Agenda for Breakout Meeting #2 (for #58B Wet Labs)

Notes of 15 April Programming Breakout Mtg. #1 (for #53 Cardio/psychophysiology Wet Lab)

UCM HBS-ME Building Program

#53 - Psych-Cardio/Psychophysiology Wet Research Lab - Opt. 1
13 April 2021 1/8"=1'-0"

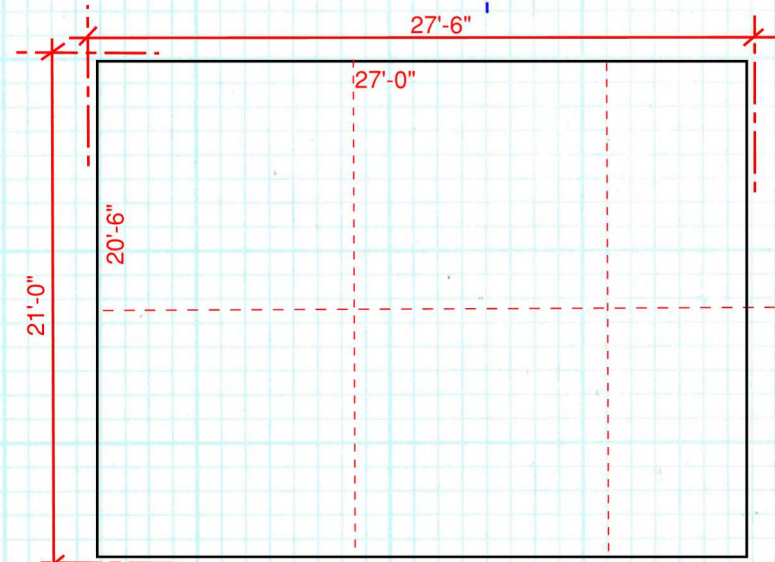
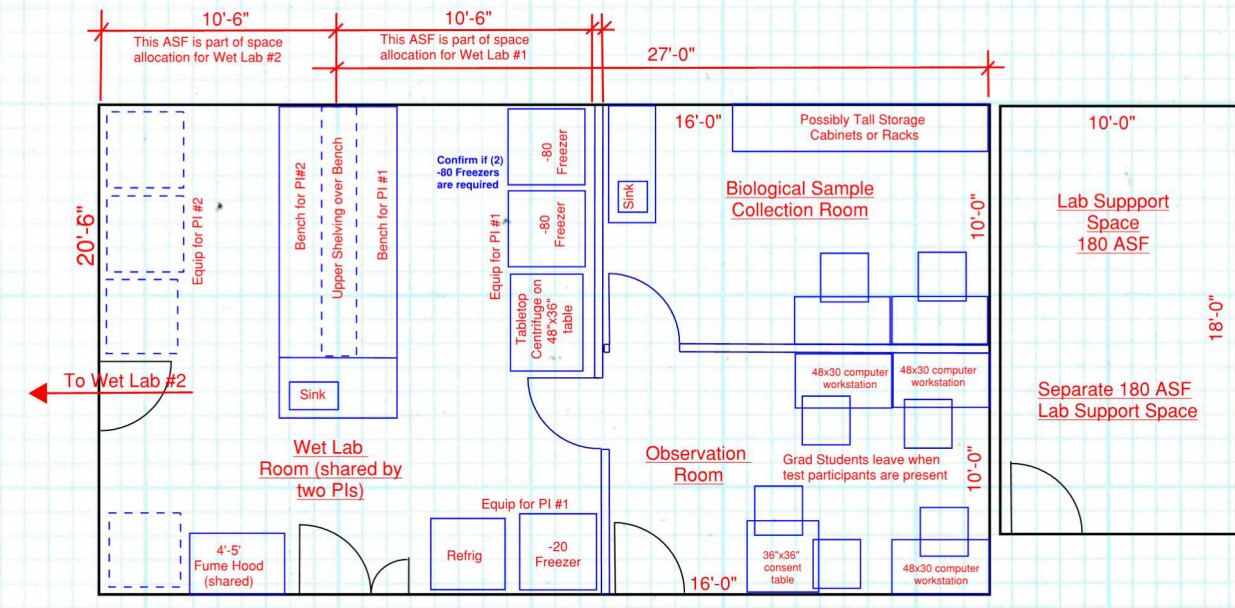
- **Room #1: Multipurpose research room** (350 sq ft) will have 8 workstations throughout the space that can support graduate students, undergraduate workers, or data collection. Off of the main space will be 6-8 small experimental cubicles (booths) each walled off from the rest of the room with their own door, windowless, soundproofed, each house a computer and integrated desk and chair, each with power supply and ethernet connection. These participants will need to be isolated. This room should have a door to Room #2.

1. Confirm count and size requirements for the experimental cubicles/booths: ***Existing Cubicles are 60"x90-1/2" but Martin H. is OK with the new cubicles being smaller if needed to fit them in as he needs a min of 6.***

2. Confirm size of computer workstations in this room. ***Desk worksurfaces are to be built-in to save space below the desk***
 3. ***Desks / test booths and workstations in Workstation Area are to each have elec and telecom***

4. ***Test Booths must be very acoustically isolated but acoustic level has not been quantified. Past experience is that conventional metal stud walls with drywall both sides (and possibly a 2nd layer on one side) plus a solid core door with acoustical gasketing on three sides and auto door bottom is adequate. Walls to either extend to structure above or have a gypsum board framed ceiling that will match room to room acoustical isolation performance of walls. Care to be taken so sound does not travel from room to room via ductwork.***

9. ***HVAC Zones: Each booth does not need to be a separate HVAC Zone. Combined group of 6 test booths to all share one HVAC zone and T-stat to be located in one of the test booths.***

#53 - Psych-Cardio/Psychophysiology Wet Research Lab - Opt. 3
(with Integrated Lab Support Area #60B)
17 April 2021 1/8"=1'-0"

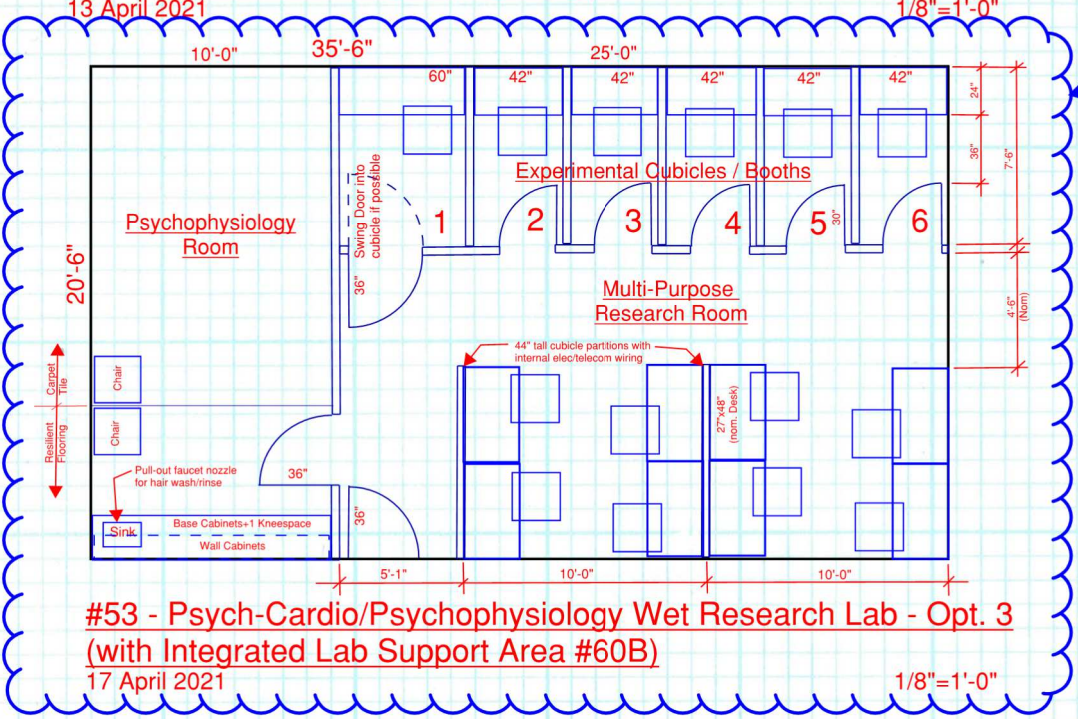
This is the selected plan layout for space #53 from the 4/15 Programming Breakout Meeting
